Addendum 01

Project: CSV Lansdowne Auditorium Renovation **Date:** 06 December 2024
330 Lansdowne Ave, **Pages incl. cover:** 21
Toronto ON

The following changes, additions, deletions and clarifications are hereby made an integral part of the documents, including the drawings and specifications for the above project.

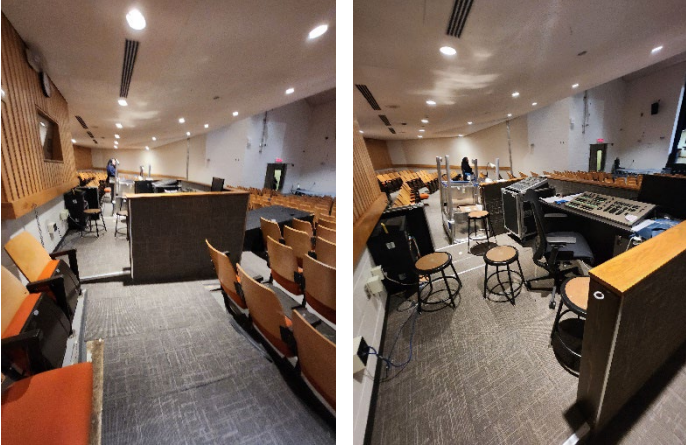
<p>Provide carpet replacement on both sides of the half-height projector podium walls. Refer to drawing 3/A1.0. and photos below of existing condition.</p>

CHECKED <i>MAK</i>	APPROVALS	ACADEMIC H. BANKS JUNE 26/84	REVISION
DRAWN <i>NEW</i>		MAINTENANCE	
DATE JUNE 11/84	JOB N° 159-30	DRAWING N° A-1	
SCALE AS NOTED	SOURCE 1984 / S 48

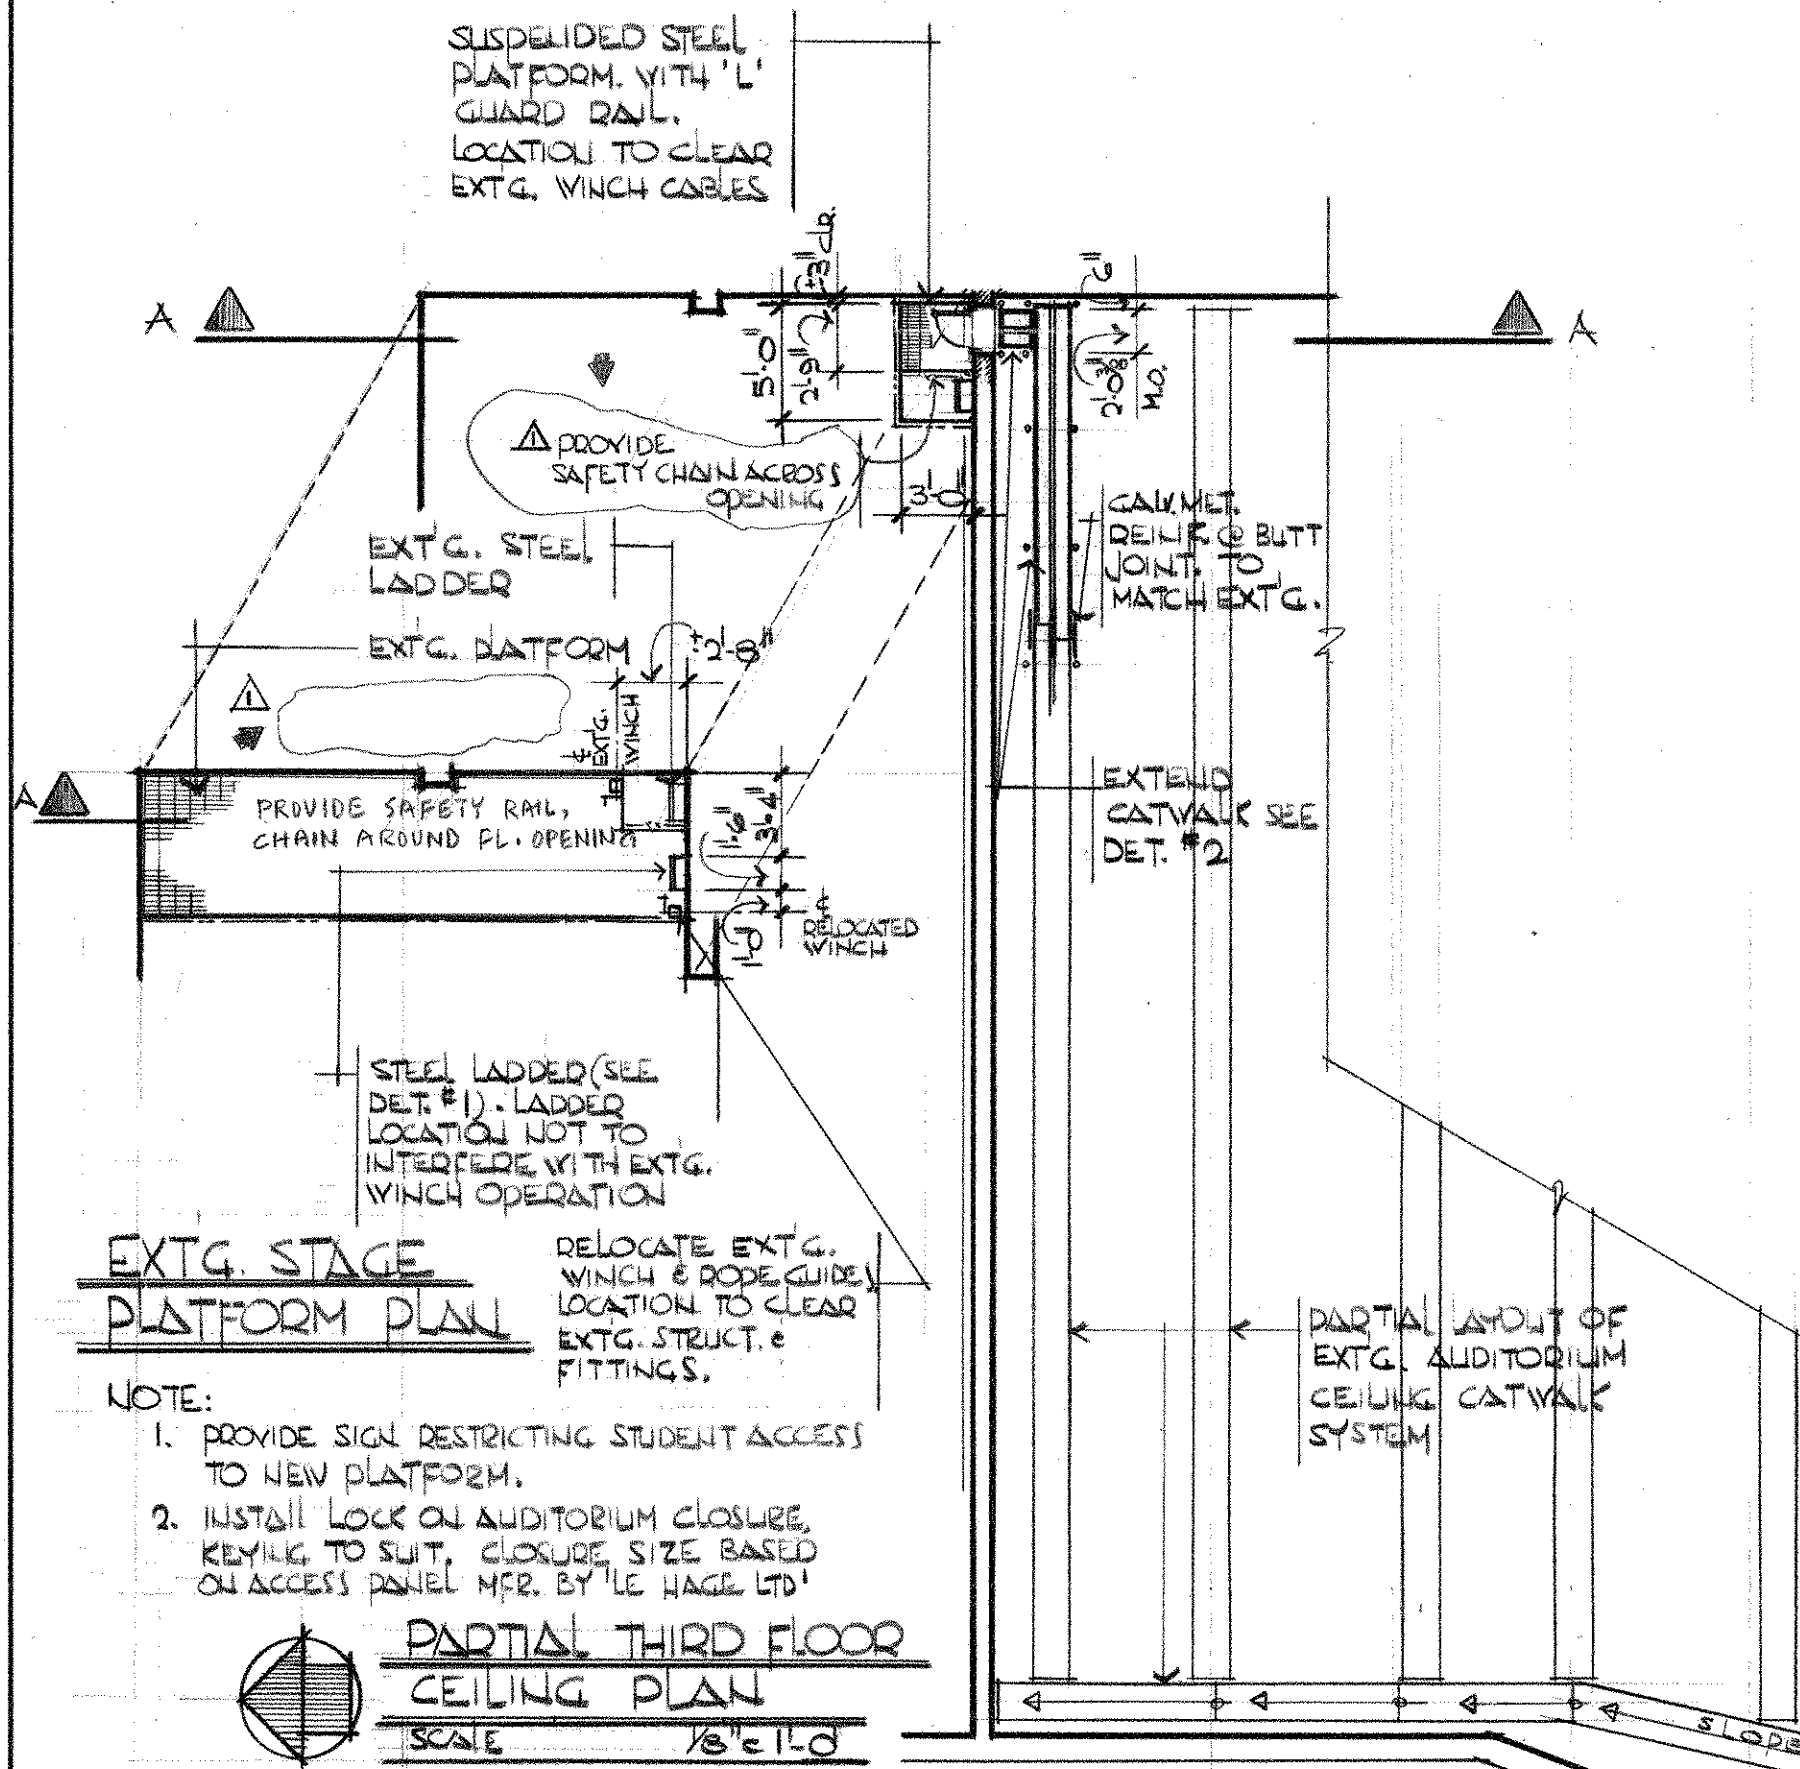
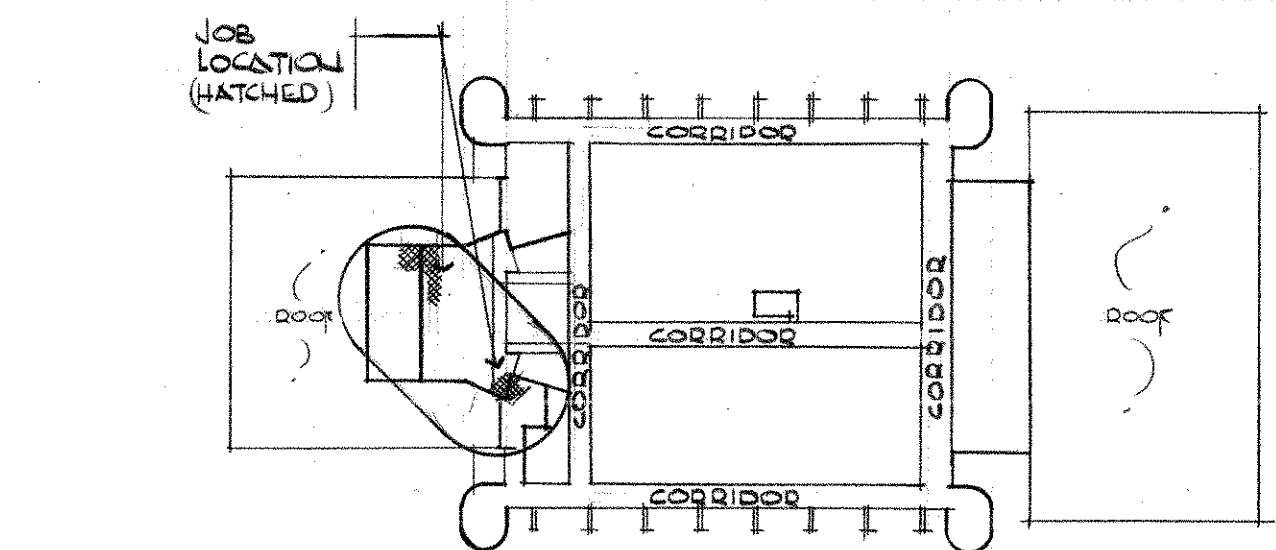
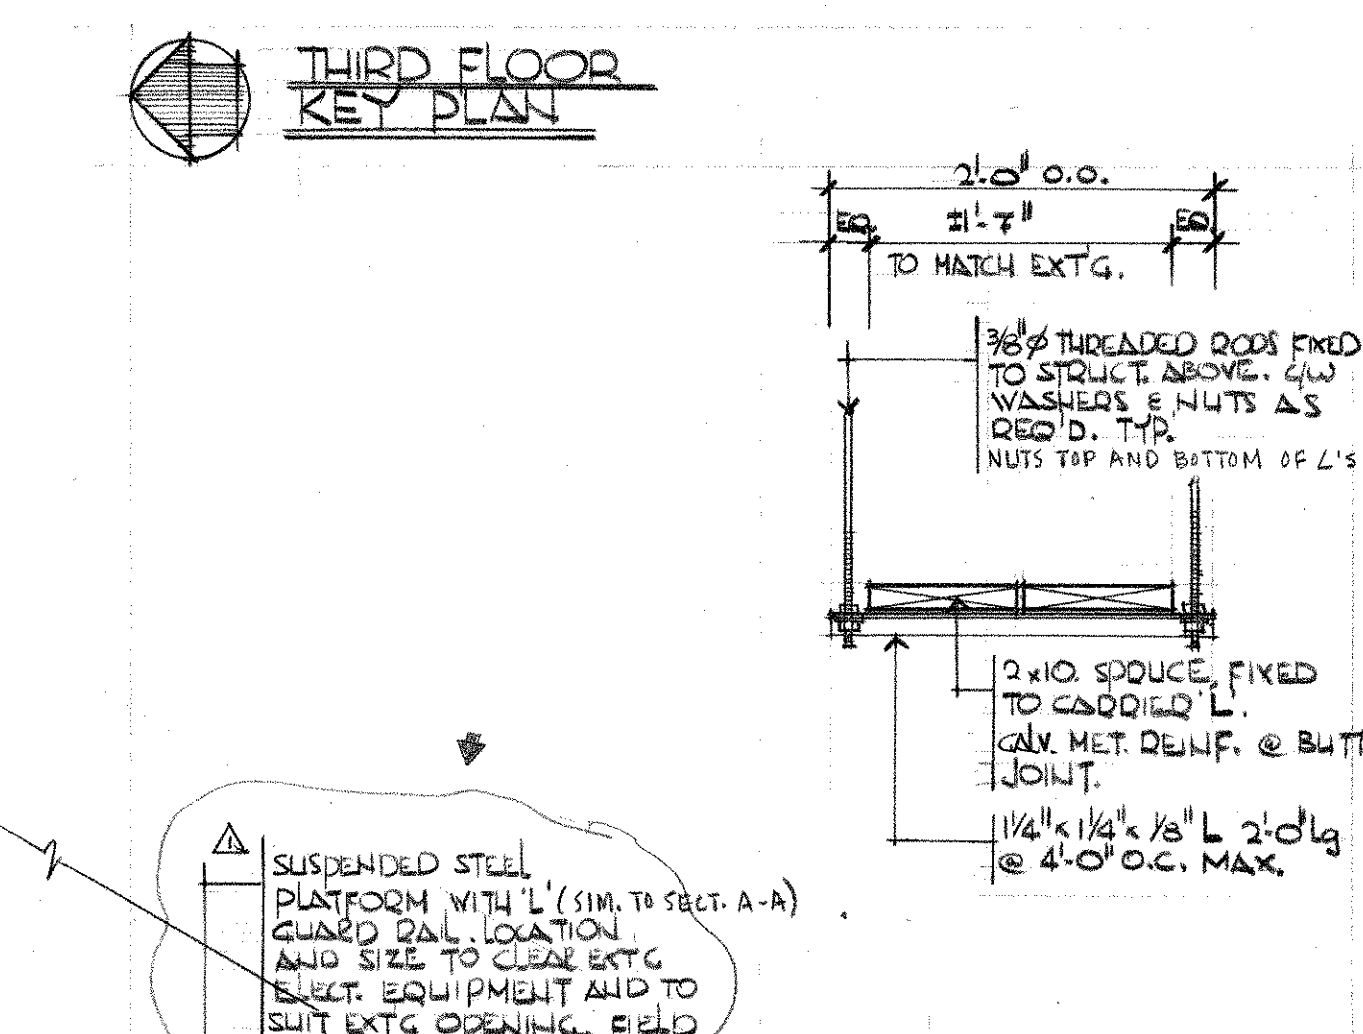
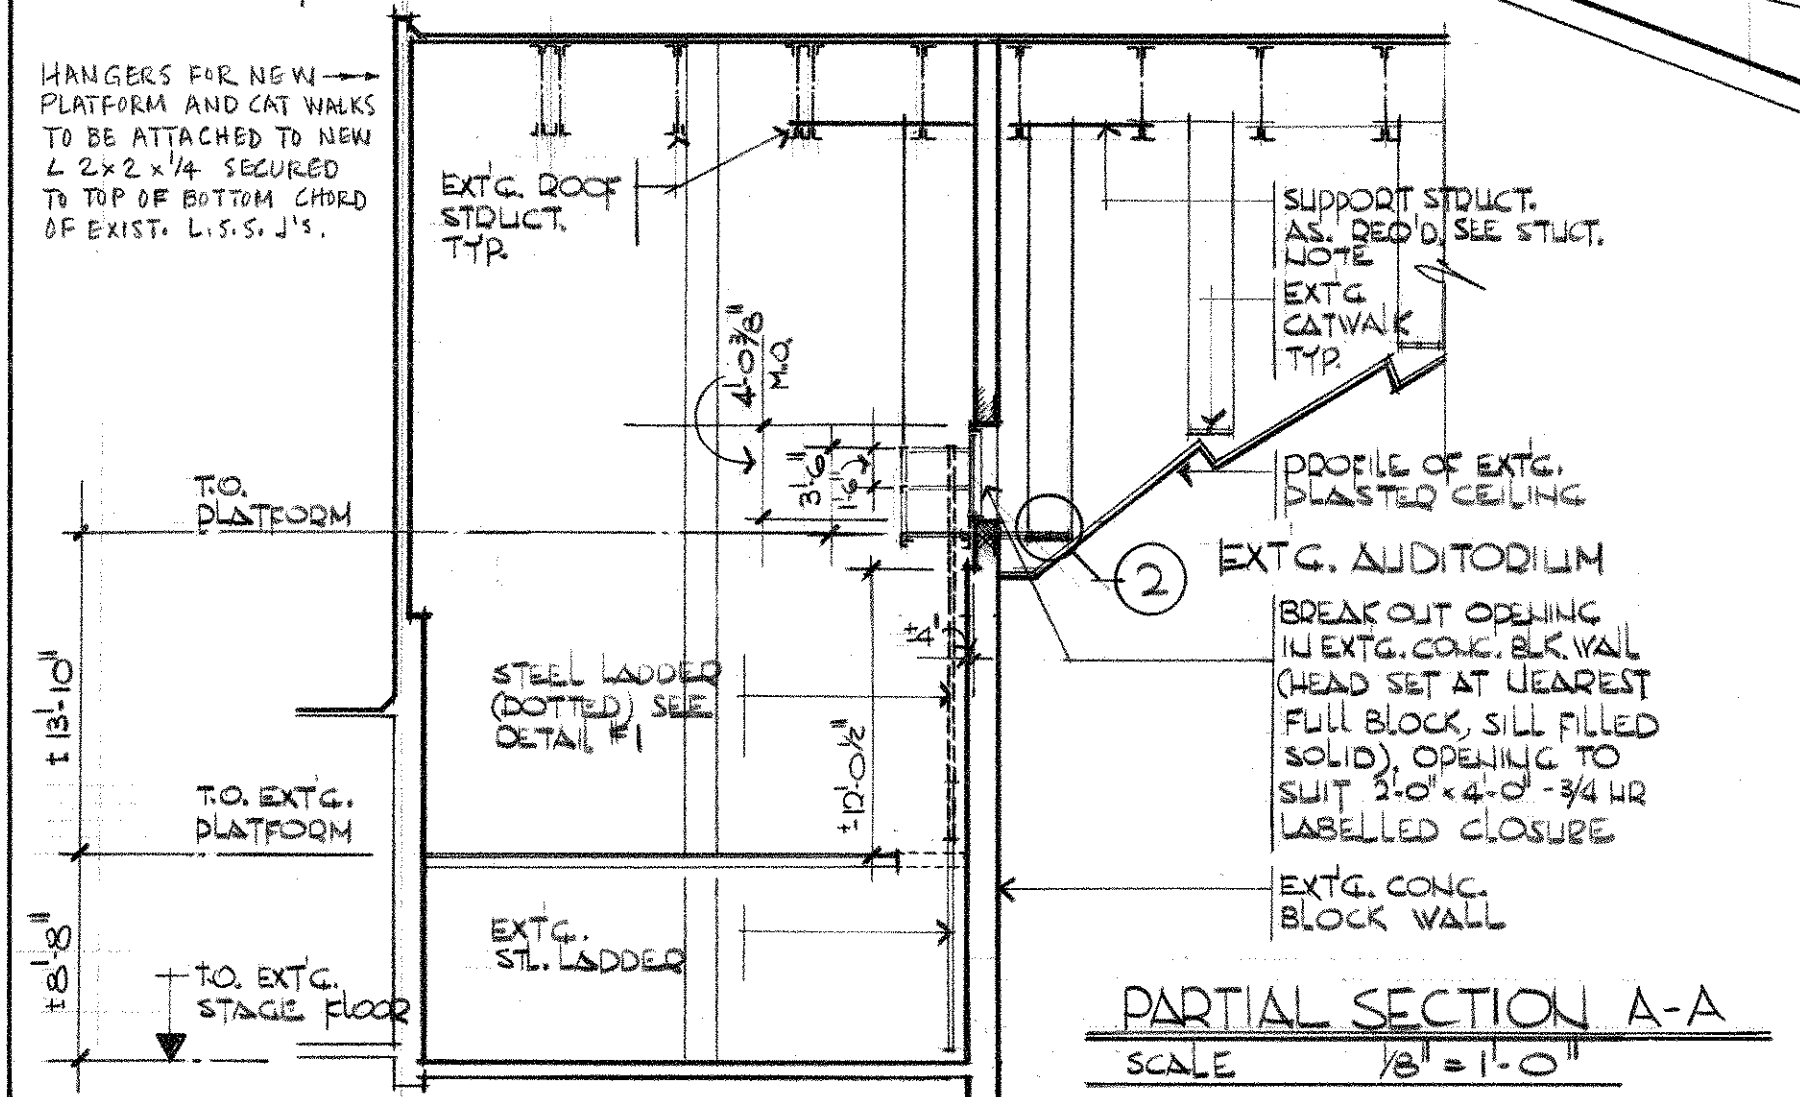
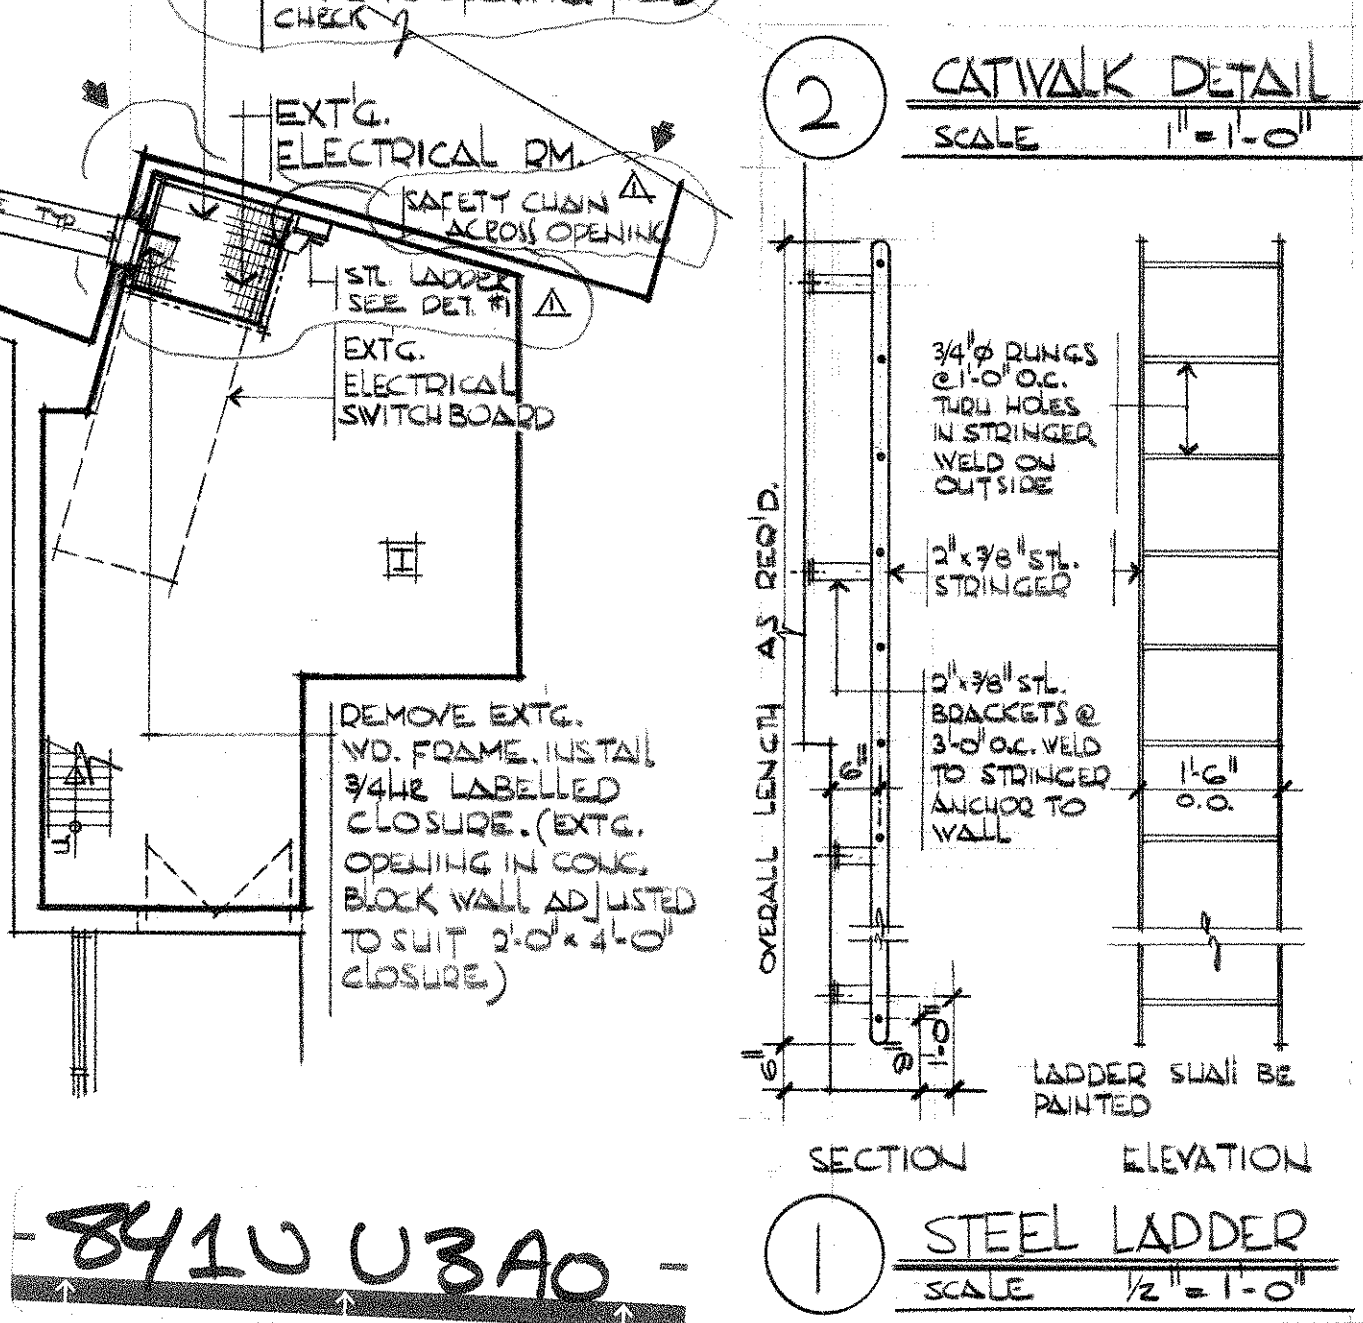
Item	Description
1.01	Clarification: Electrical Legend & Details Refer to Electrical Addendum E-1 (2 pages)
1.02	Clarification: Pre-qualified Abatement Remediation Contactors Refer to Appendix B2 - Subcontractors for updated list
1.03	Clarification: Access to ceiling space above auditorium Refer to record drawing A-1 of catwalk in accessible ceiling above the auditorium. Refer to photos below of existing condition, taken from outside the Level 3 electrical room access hatch. Drawings and photos are provided for information only and It is the contractor's responsibility to verify their accuracy. 
1.04	Clarification: Flooring replacement in Passageway 1-13 Remove and replace RES flooring and RB nosing at existing stair in Passageway 1-13. Refer to room finish schedule on drawing A0.1 and A3/A1.0.
1.05	Addition: Carpet replacement at main auditorium projector podium walls.
